JAMES A. FITZPATRICK NUCLEAR POWER PLANT

AMENDMENT TO FACILITY OPERATING LICENSE

Amendment No. 88
License No. DPR-59

SAFETY EVALUATION BY THE OFFICE OF NUCLEAR REACTOR REGULATION

Figure 3.1-2

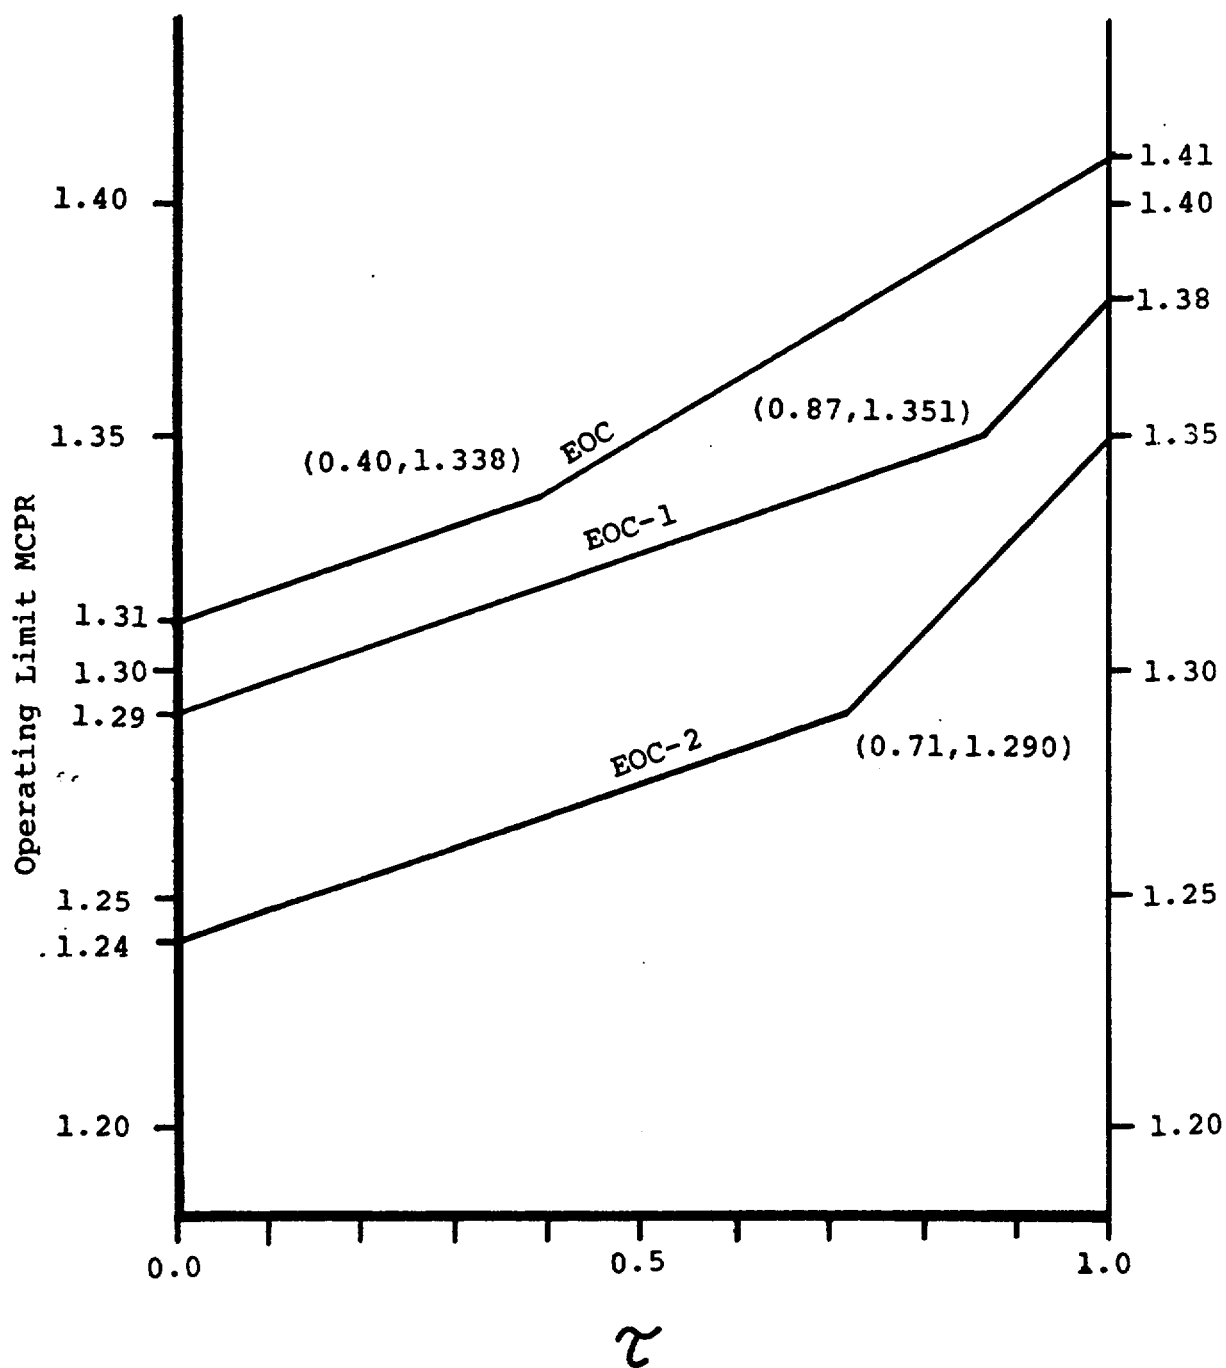
The proposed changes to the FitzPatrick Technical Specifications would specify the Minimum Critical Power Ratio (MCPR) Operating Limit for Incremental Cycle Core Average Exposure, define the vs. Operating Limit MCPR and identify the Maximum Average Planar Linear Heat Generation Rate (MAPLHGR) limits for all fuel types for Cycle 7 operation. In addition, specifications relating to discharged fuel types would be deleted.

To assure that the fuel cladding integrity safety limit MCPR will not be violated during any anticipated transient, the most limiting events were reanalyzed for this reload (Reference 2) to determine which events result in the largest reduction in MCPR. The operating limit MCPR was then established by adding the largest reduction factor in the MCPR to the safety limit MCPR. Since acceptable methods (Reference 4) have been used, we find the MCPR Technical Specification changes to be acceptable.

Operating Limit MCPR
Versus τ (Defined in Section 3.1.B.2)
FOR ALL FUEL TYPES

Figure 3.5-11

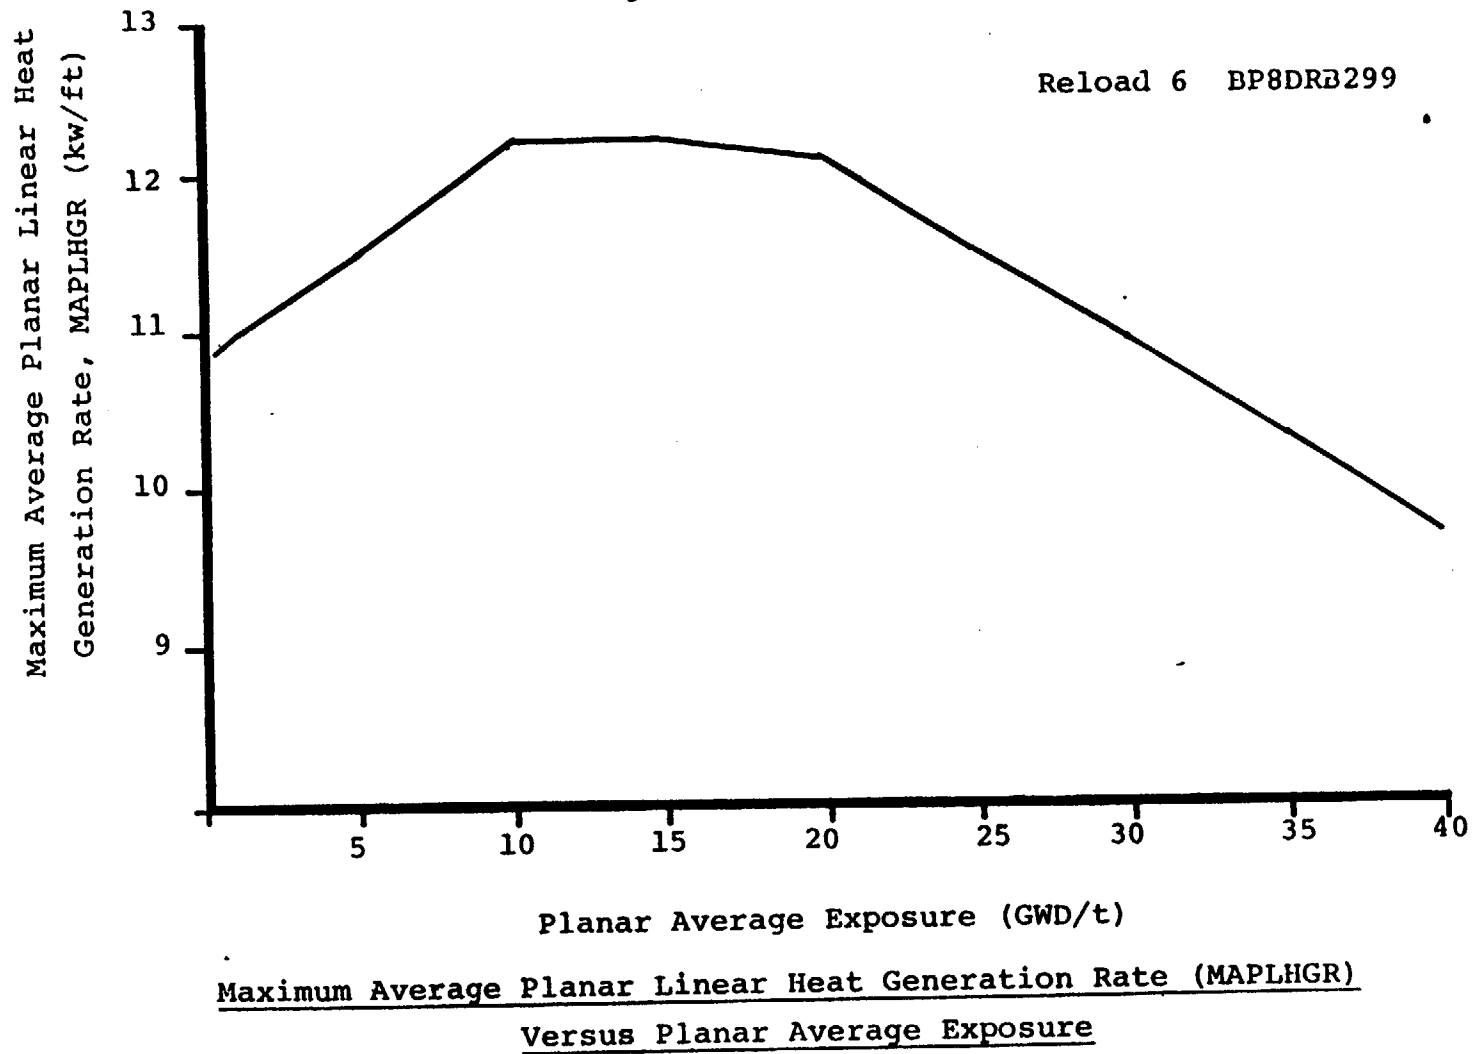
The APLHGR for each type of fuel as a function of average planar exposure shall not exceed the limiting value shown in Figures 3.5-9 through 3.5-11. If anytime during reactor power operation greater than 25% of rated power it is determined that the limiting value for APLHGR is being exceeded, action shall then be initiated within 15 minutes to restore operation to within the prescribed limits. If the APLHGR is not returned to within the prescribed limits within two (2) hours, an orderly reactor power reduction shall be commenced immediately. The reactor power shall be reduced to less than 25% of rated power within the next four hours, or until the APLHGR is returned to within the prescribed limits.

The MAPLHGR limit specified in the proposed Technical Specification changes is consistent with Reference 3 and is, therefore, acceptable.
